Building Review (paul.skidmore)

PROJECT: BOYLE RESIDENCE
DRAWING TITLE: MERCER ISLAND, WA
GENERAL NOTES

SHEET NO. S1.1

PROJECT	DATE
BOYLE RESIDENCE MERCER ISLAND, WA	07/25/17
DRAWING TITLE	REVISED
DETAILS	
SHEET NO.	
S3.2

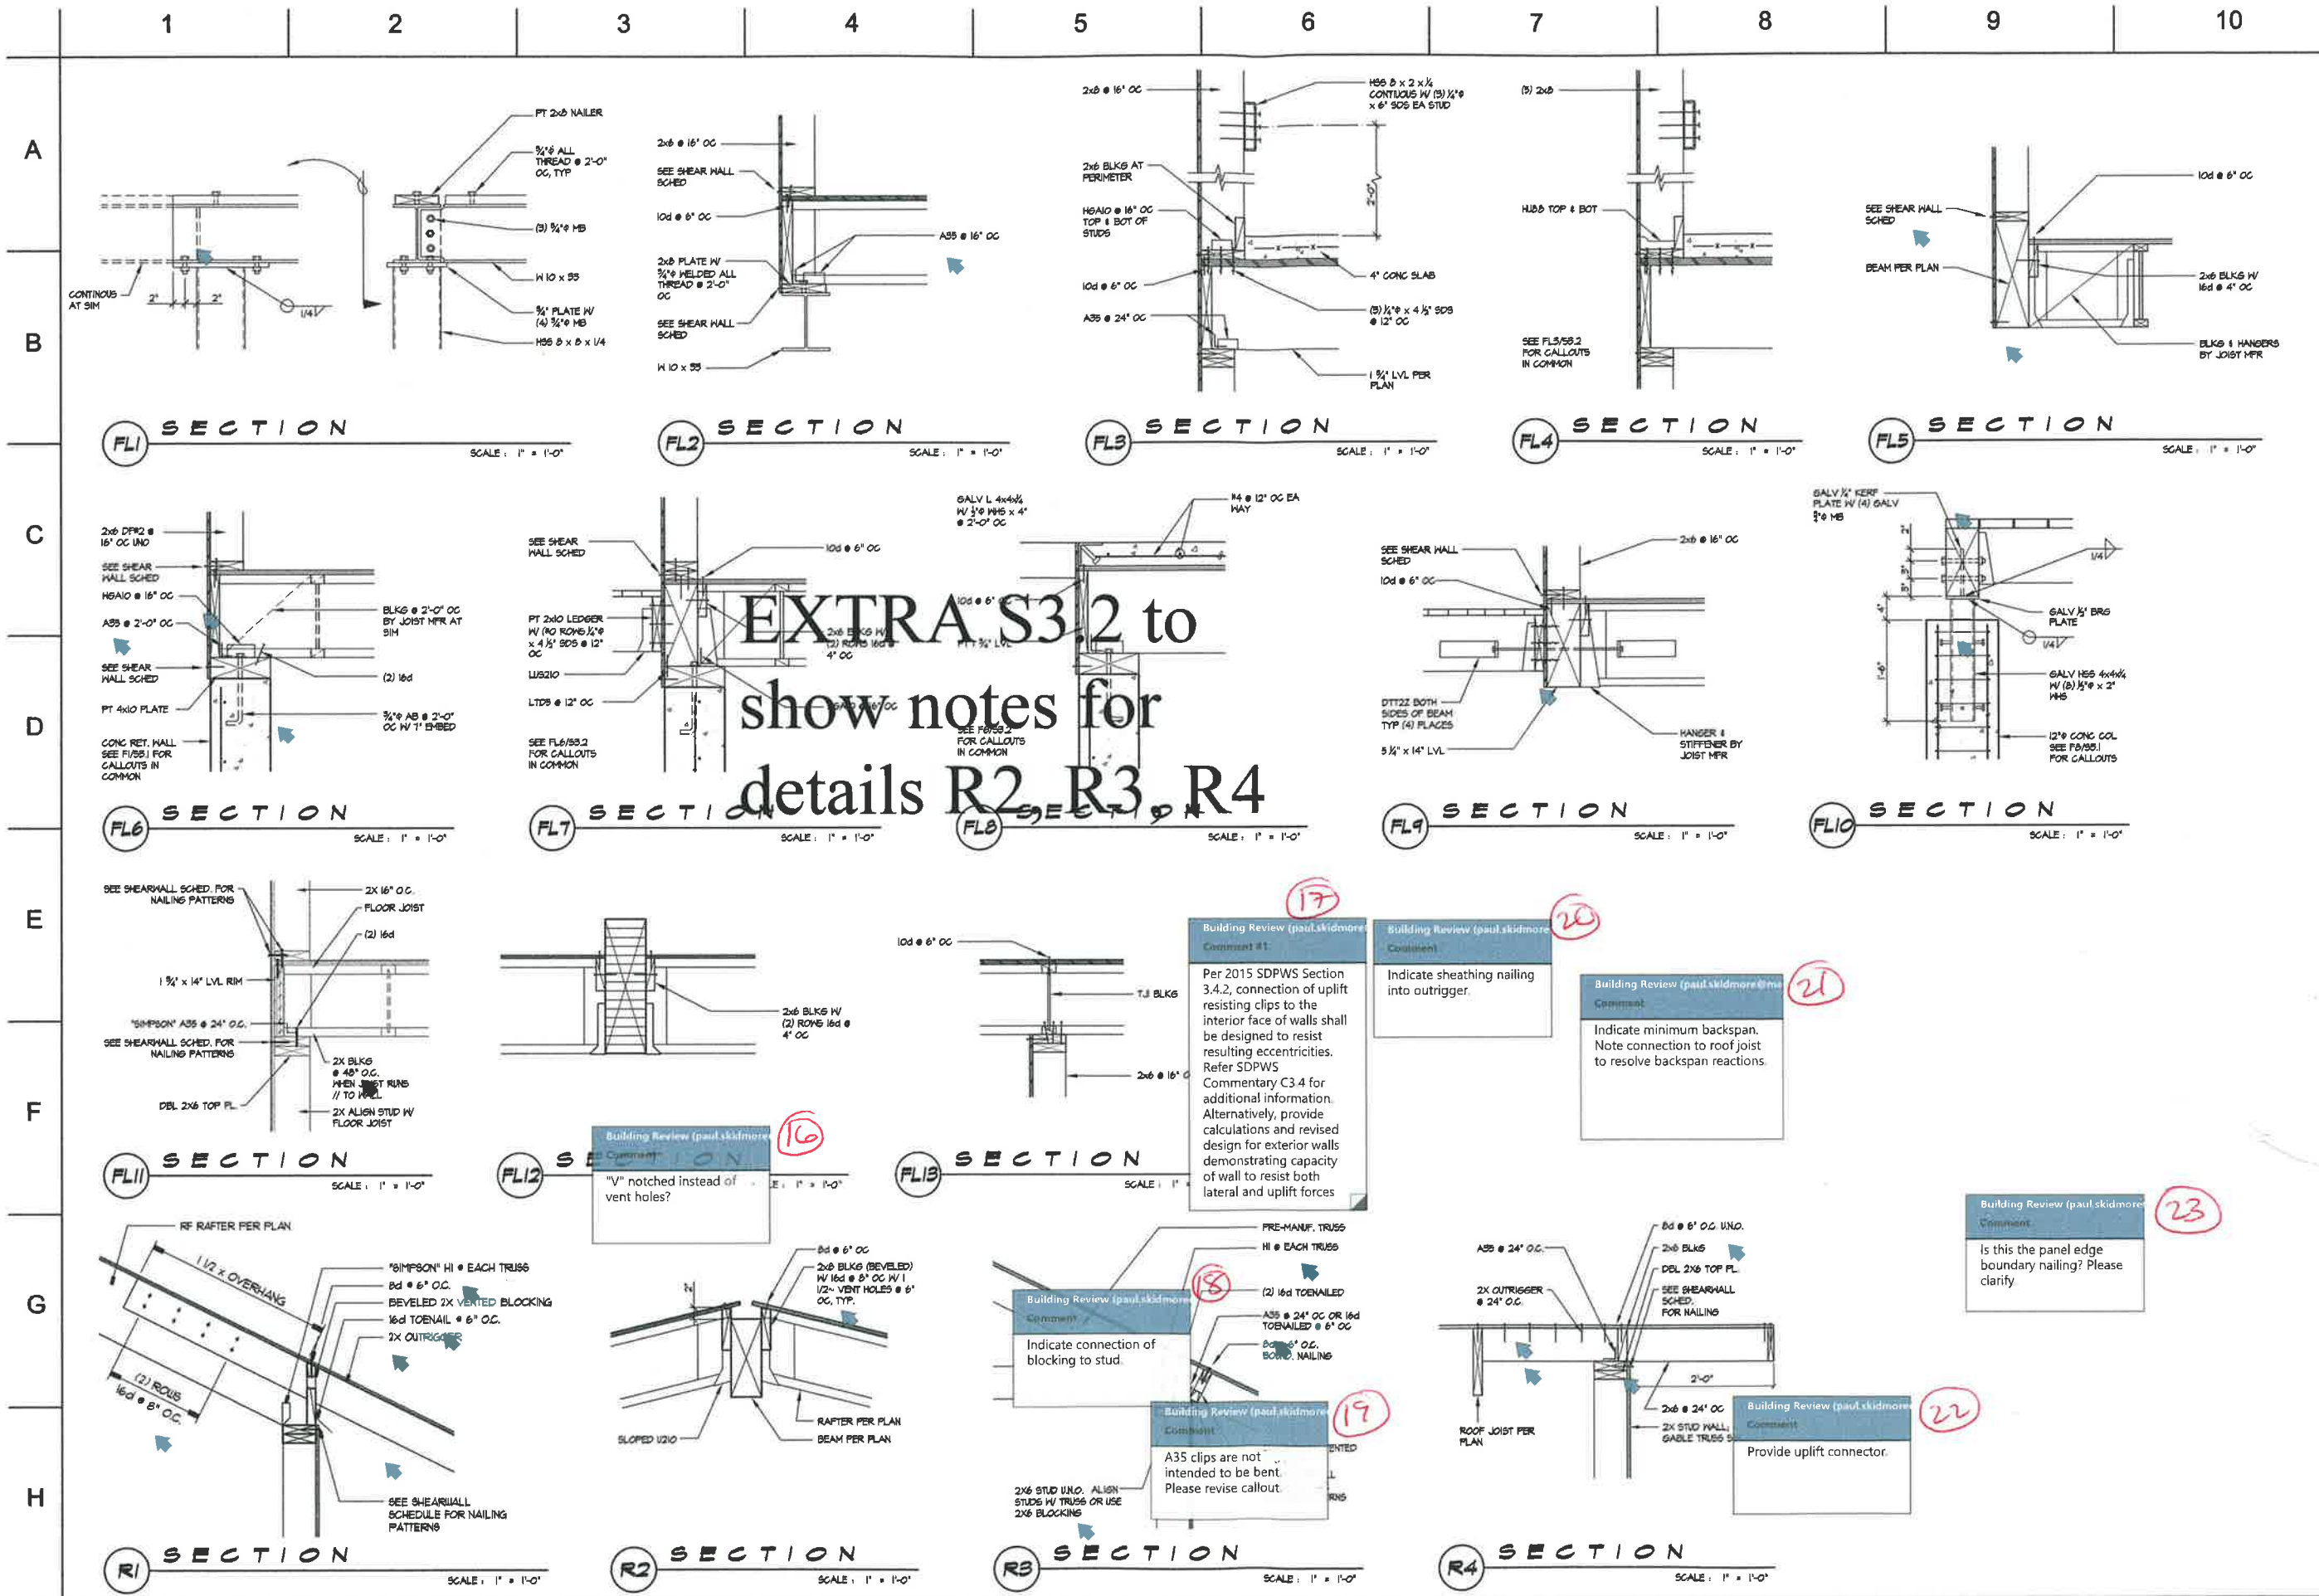
17
 Building Review (paul.skidmore) Comment #1
 Per 2015 SDPWS Section 3.4.2, connection of uplift resisting clips to the interior face of walls shall be designed to resist resulting eccentricities. Refer SDPWS Commentary C3.4 for additional information. Alternatively, provide calculations and revised design for exterior walls demonstrating capacity of wall to resist both lateral and uplift forces.

20
 Building Review (paul.skidmore) Comment #1
 Indicate sheathing nailing into outrigger.

21
 Building Review (paul.skidmore) Comment #1
 Indicate minimum backspan. Note connection to roof joist to resolve backspan reactions.

23
 Building Review (paul.skidmore) Comment #1
 Is this the panel edge boundary nailing? Please clarify.

18
 Building Review (paul.skidmore) Comment #1
 Indicate connection of blocking to stud.

19
 Building Review (paul.skidmore) Comment #1
 A35 clips are not intended to be bent. Please revise callout.

22
 Building Review (paul.skidmore) Comment #1
 Provide uplift connector.
